Model: Kir-C		Date: 15-May-01	No.: RB040001
Subject: ROM History (Kir-C1 Copy Version)		Prepared by: K. Miura	
From: Technical Services Dept., GTS Division			
Classification:	<input type="checkbox"/> Troubleshooting <input type="checkbox"/> Part information <input type="checkbox"/> Action required <input type="checkbox"/> Mechanical <input type="checkbox"/> Electrical <input type="checkbox"/> Service manual revision <input type="checkbox"/> Paper path <input type="checkbox"/> Transmit/receive <input checked="" type="checkbox"/> Retrofit information <input type="checkbox"/> Other (      )

Firmware history for the Kir-C1

Model: Kir-C		Date: 24-May-01	No.: RB040003
Subject: Note for replacing the Drum Shutter Gear		Prepared by: K. Miura	
From: Technical Services Dept., GTS Division			
Classification:	<input checked="" type="checkbox"/> Troubleshooting <input checked="" type="checkbox"/> Mechanical <input type="checkbox"/> Paper path <input type="checkbox"/> Other (      )	<input type="checkbox"/> Part information <input type="checkbox"/> Electrical <input type="checkbox"/> Transmit/receive	<input type="checkbox"/> Action required <input type="checkbox"/> Service manual revision <inp

**OK: no gap****NG: gap**

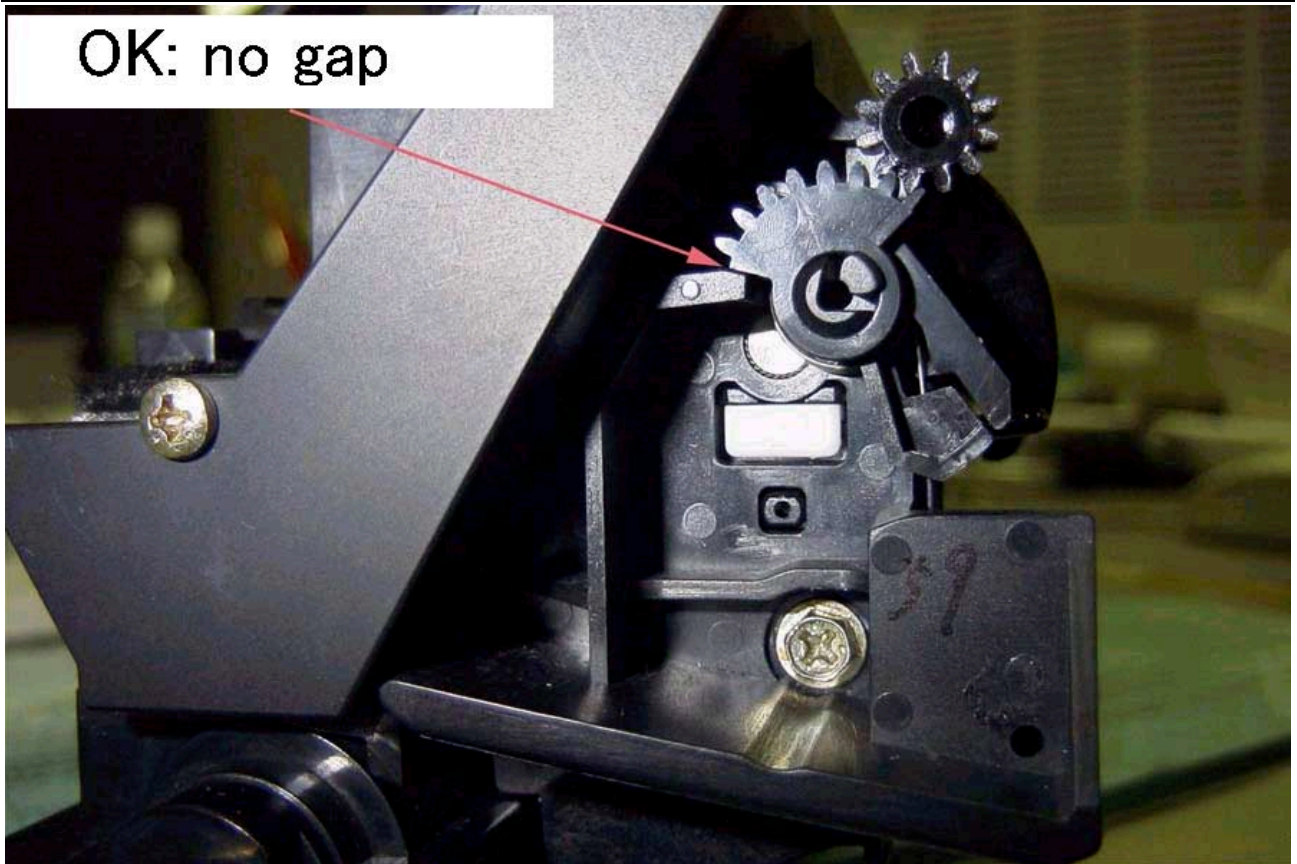
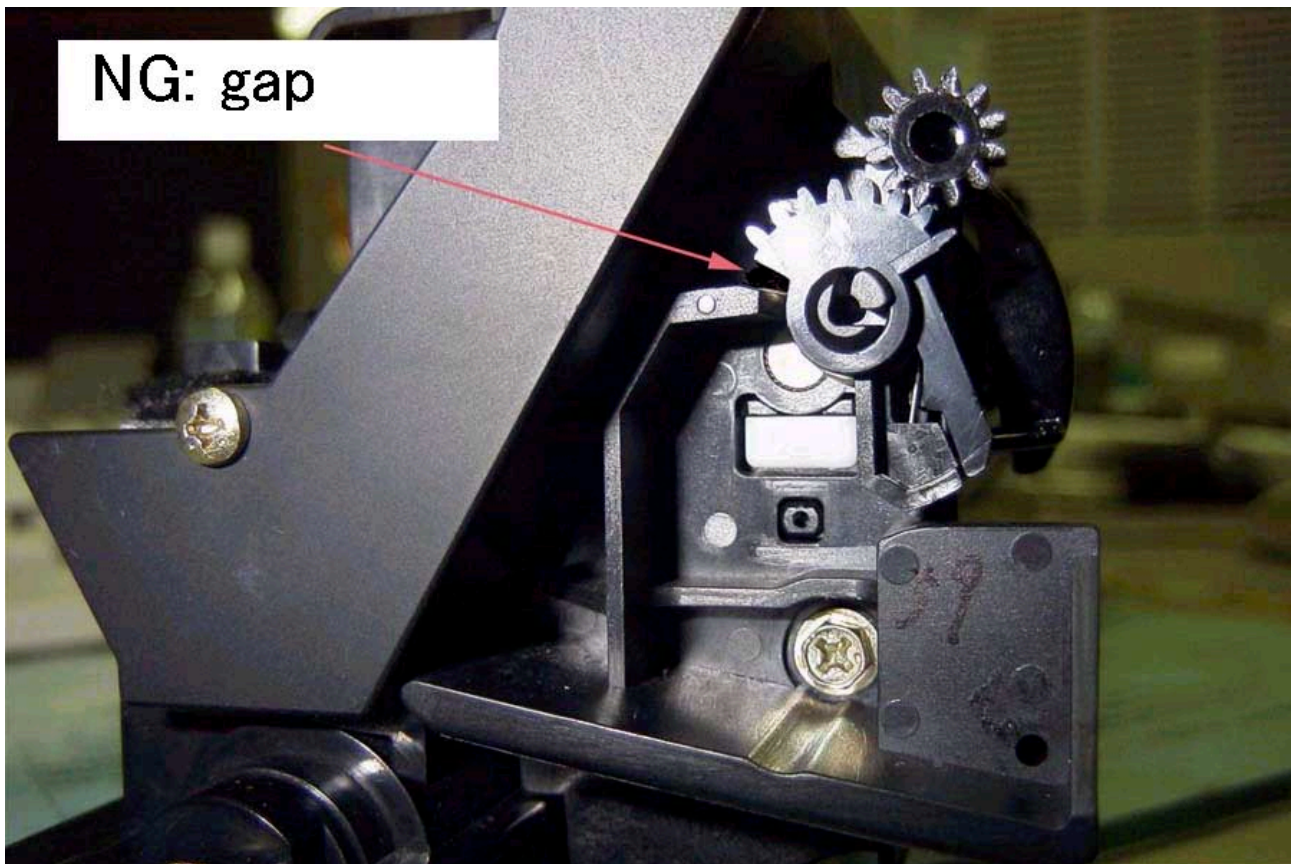
When re-installing the Drum Shutter Gear (B0392362), if there is a gap between the Drum Shutter Gear and Drum Front Side Plate (B0392361), the drum shutter will not open fully. See the photo images on the next page.

The gap causes the Drum Shutter Gear to rotate less.

When re-installing, it is necessary to confirm that there is no gap between the shutter gear and front side plate. A Drum Shutter Stopper (B0392325) has been added from May 2001 production to ensure that the Drum Shutter Gear and Drum Front Side Plate are held flush together with no gap.

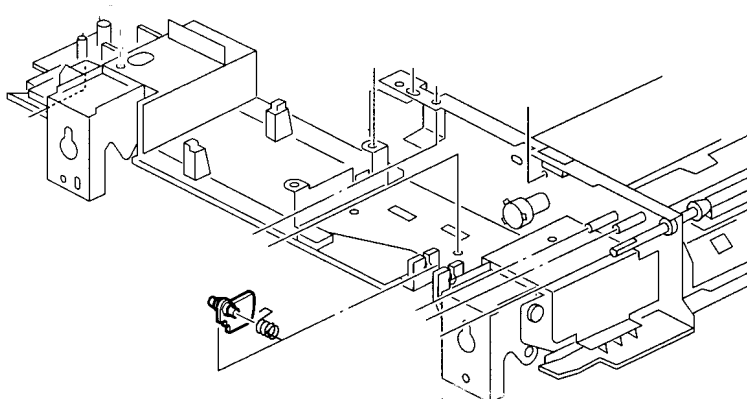
The ADF Paper Size Sensor Feeler (B3871941) sometimes detaches when the ADF is removed from the package.

There are slight variations in shaft width, which can sometimes cause the feeler to detach if the shaft is too thin.

When installing the ADF, check that the Paper Size Sensor Feeler is properly in place. If it comes off, re-set the feeler.

Note that this only occurs at installation. Since the feeler will normally stay attached during operation, it is not necessary to replace it when this occurs. The feeler shaft and surrounding areas have been fortified from May 2001 production (suffix change).

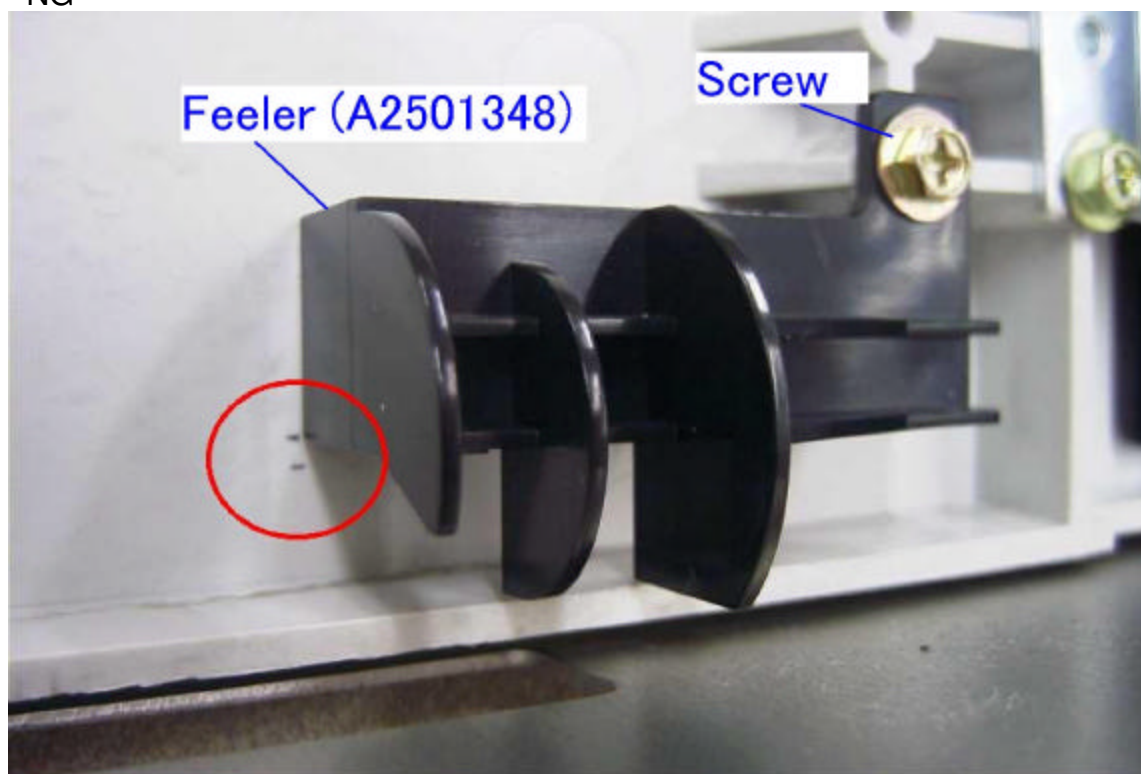
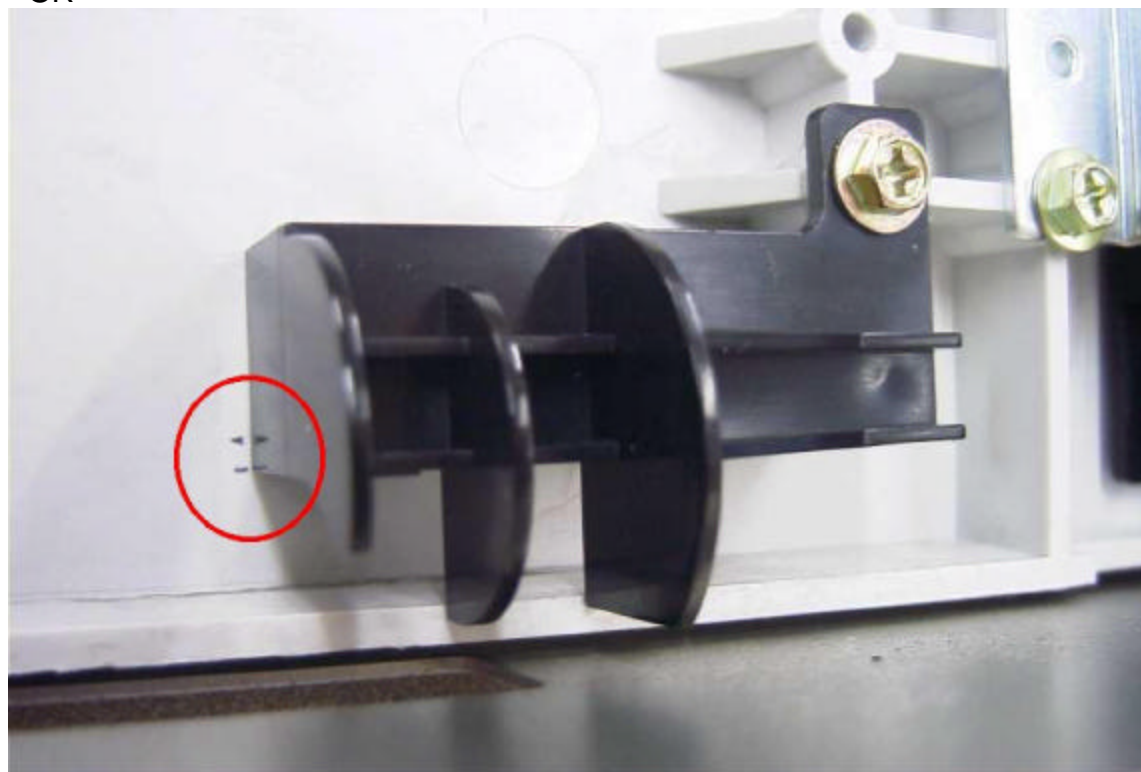
When the customer sets an A4 SEF original, the machine incorrectly detects LG instead of A4 SEF.

The APS detects the platen cover itself because it activates the platen cover sensor. There are two causes as follows:

1. The Platen Cover Feeler (A2501348) is held in place by a screw. However, the screw hole is a little wide and the feeler may not be fixed at the right position. When it is not fixed at the right position, the APS sensor is placed closer to the platen cover than the standard and it detects the platen cover. If the APS sensor detects the platen cover, the machine cannot make the right decision for the document size (see the attached "NG" file and service manual P. 6-11).
2. The APS sensor is closer to the rear of the machine than it was on the previous model. This places the APS sensor closer to the platen cover and causes it to detect the platen cover.

For a temporary solution, adjust the position of the feeler as shown in the attached "OK" picture. For the final solution, we will change the shape of the feeler to determine the paper size at a deeper angle.

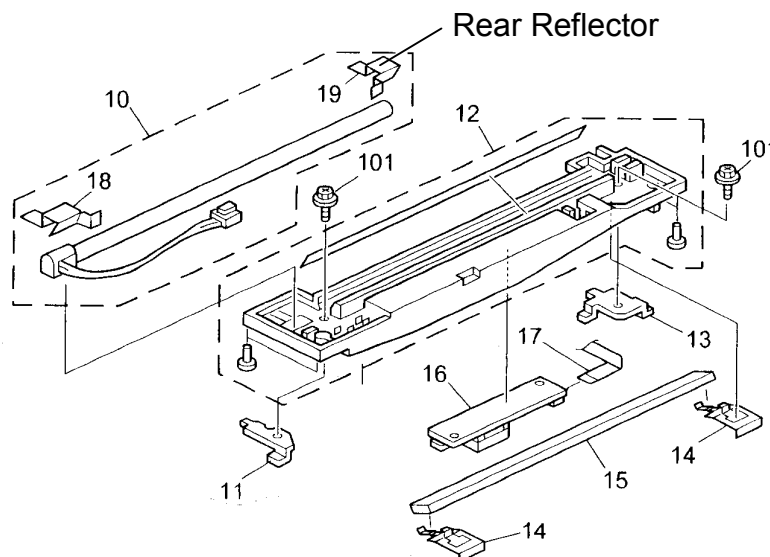
SC122, noise from the scanner and/or jittering in half-tone areas.

The rear reflector of the 1st scanner is misaligned, impacting the inner frame of the scanner unit when the scanner moves.

Perform a scanner free run with SP4-013 to determine if the rear reflector is out of position.

1. Turn off the main power and remove the exposure glass and top rear cover.
2. Remove the misaligned reflector and replace it with a new one.

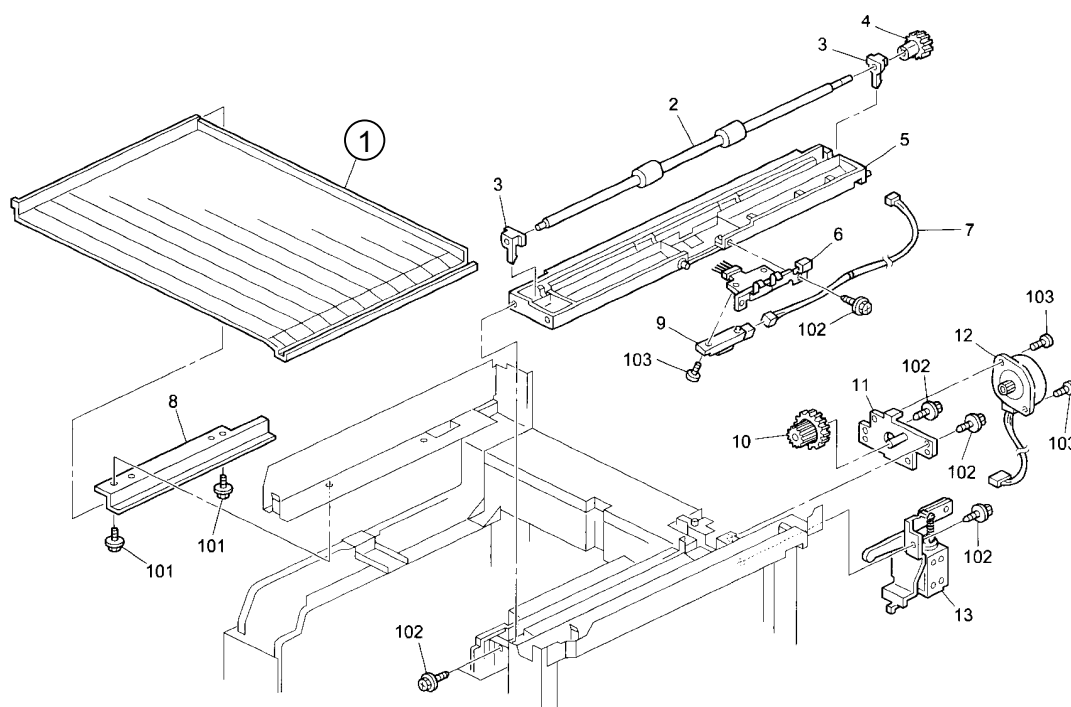
Duplex jamming

The Reverser Shelf can sometimes come out of position during transport.

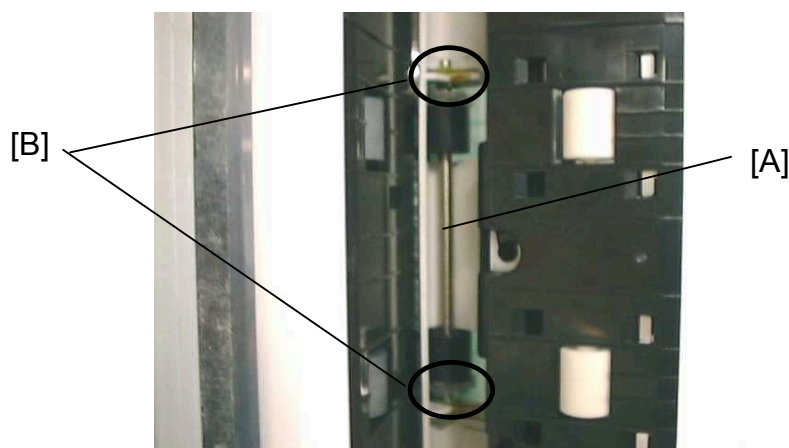
The Exit Roller Springs come off due to impact or excessive shock (e.g. during transport), which can sometimes cause the Bushing and Exit Roller to come off as well.

As a permanent solution, the shape of the bushing has been changed and a cardboard pad has been added to protect the Exit Roller from shock.

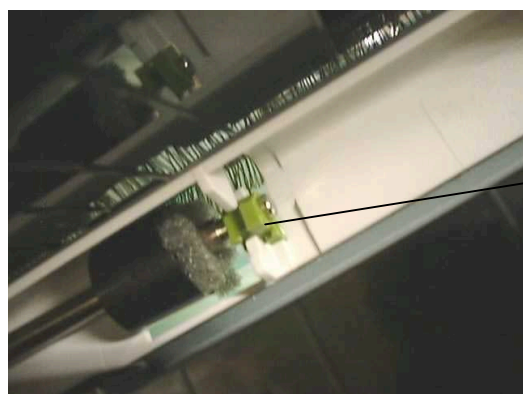
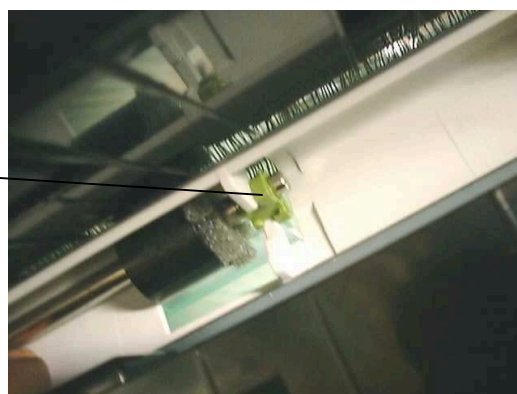
However if **only one** Bushing has come off, set the Bushing [D] as shown below:

6. Set the Springs [E], starting with the upper spring, then the lower one.

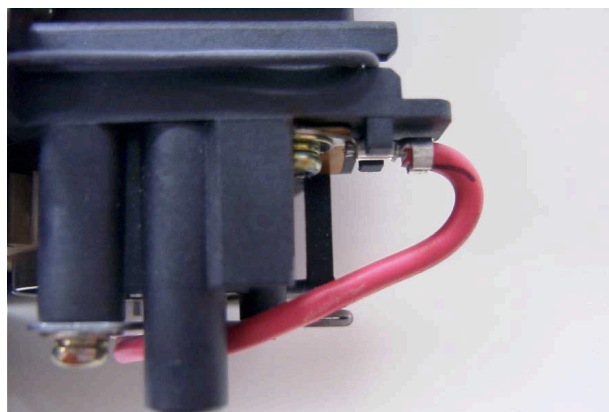
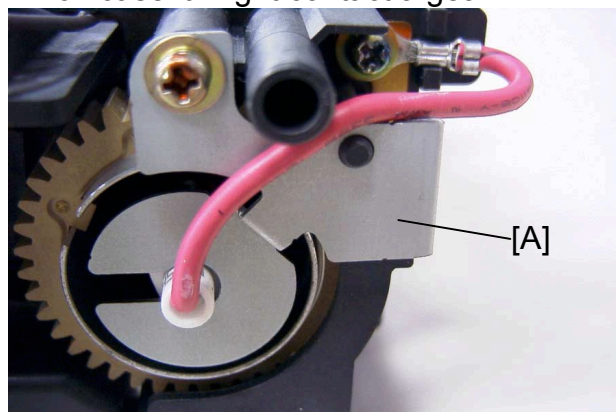
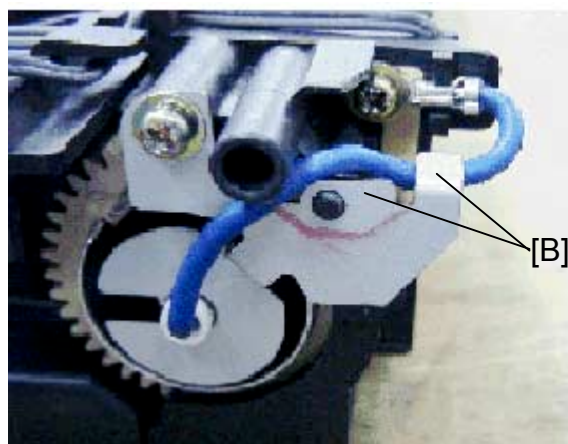
If the rear holder [A] is removed, the fusing lamp harness is damaged by one of the gears in the gearbox.

The problem occurs if the harness of the fusing lamp is not routed over the rear holder. The fusing lamp harness tends to drop and may contact one of the gears in the gearbox.

The rear holder has been modified.

The rear holder has been modified [B] to hold the harness in position. Route the harness over the rear holder as shown.

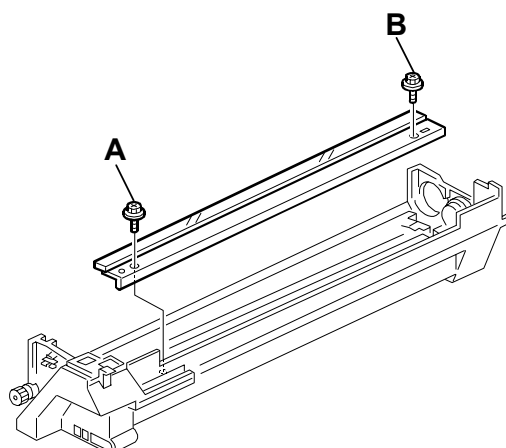
The two cleaning blade fixing screws loosen, or one of the screws (A below) comes loose and falls out.

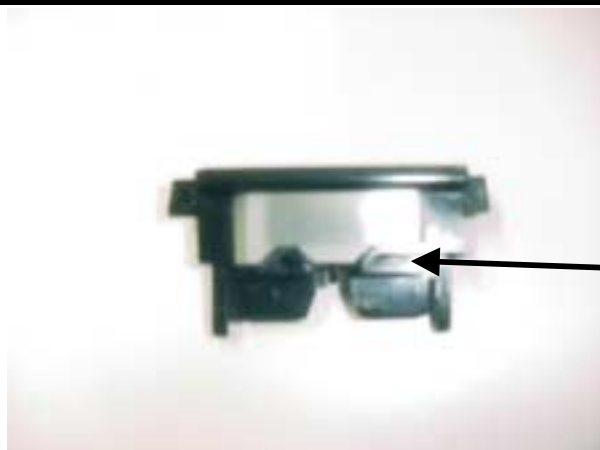
Non-feed jams caused by the burred friction pad will occur when the paper tray is nearly full.

- (1) Replace the friction pad.

- (2) Remove the burr with grade 800 to 1000 sandpaper
